City of Portland, Maine - Building or Use Permit Application 389 Congress Street, 04101, Tel: (207) 874-8703, FAX: 874-8716

BUILDING PERMIT REPORT

DATE: 20 APRIL 2008 ADDRESS: 43 Continental Dr. CBL: 352-C-0008
 REASON FOR PERMIT: Amend Permit #991032 add decks (3)
 BUILDING OWNER: J. Barton Seymour
 PERMIT APPLICANT: _____ / CONTRACTOR Owner
 USE GROUP: R-3 CONSTRUCTION TYPE: 53 CONSTRUCTION COST: \$2,400,000 PERMIT FEES: \$47,000

43 CONTINUING DE.

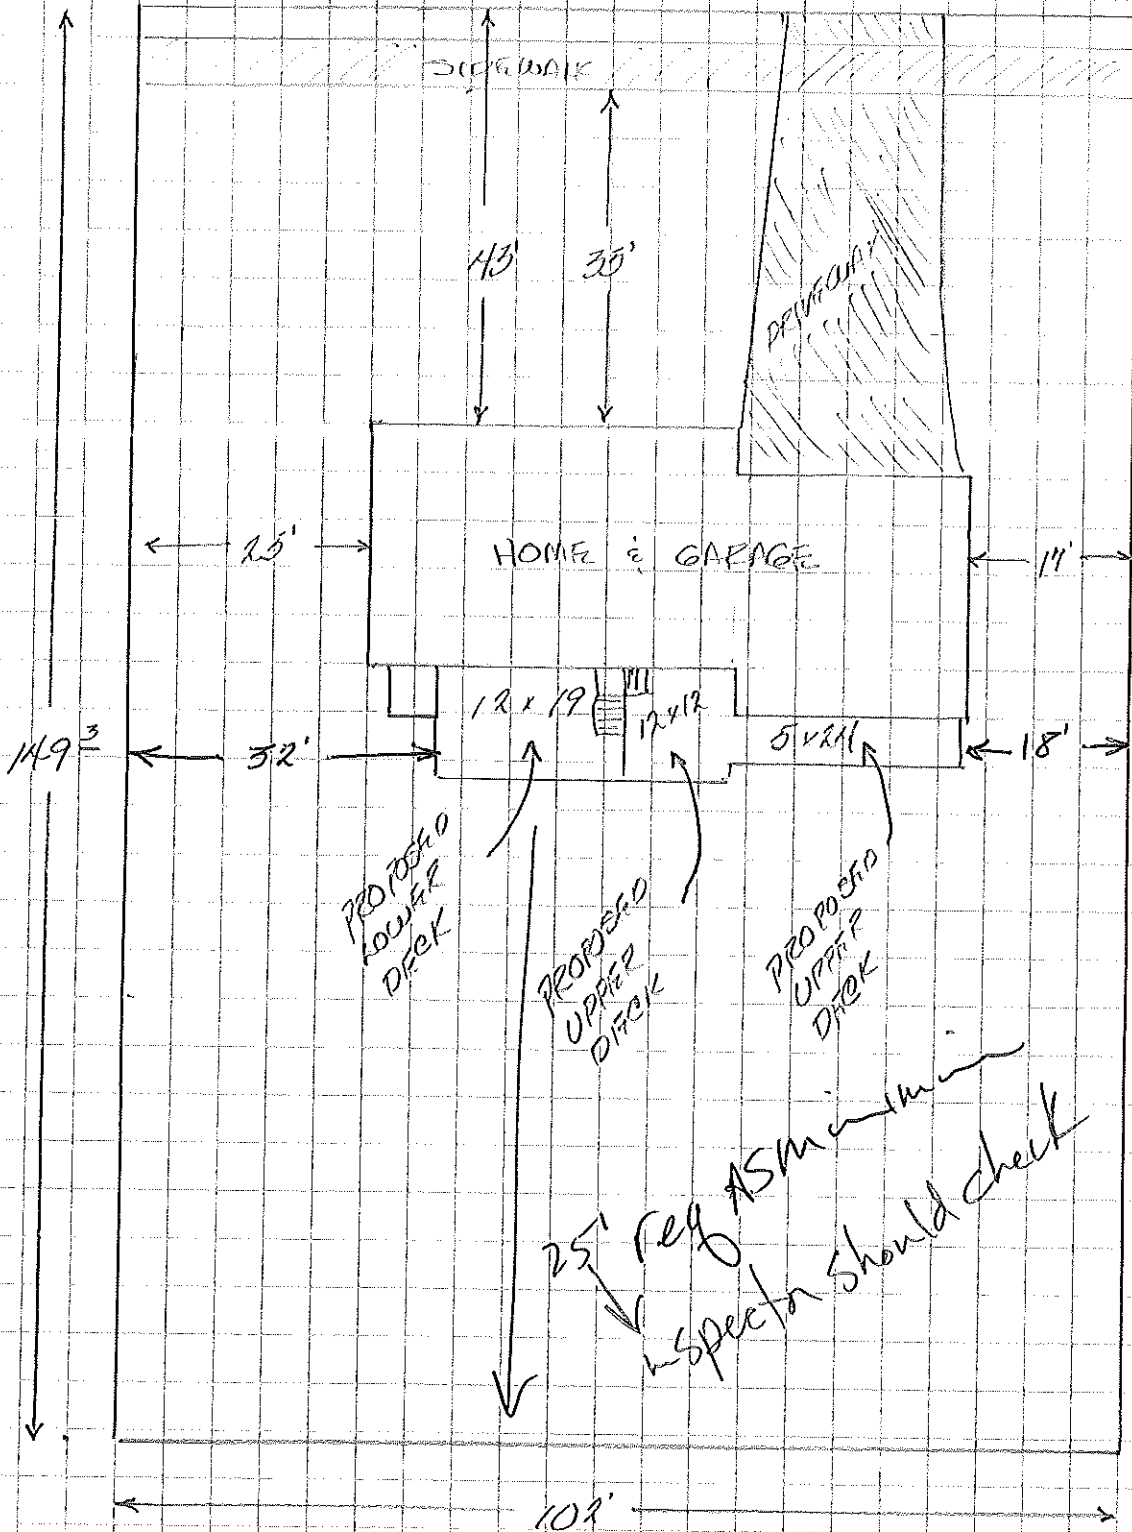
25' Reg ASM in min
- spectra should check

REAR: 25' reg -
shows more

SIDES: 14' reg
18' 32' show
OK
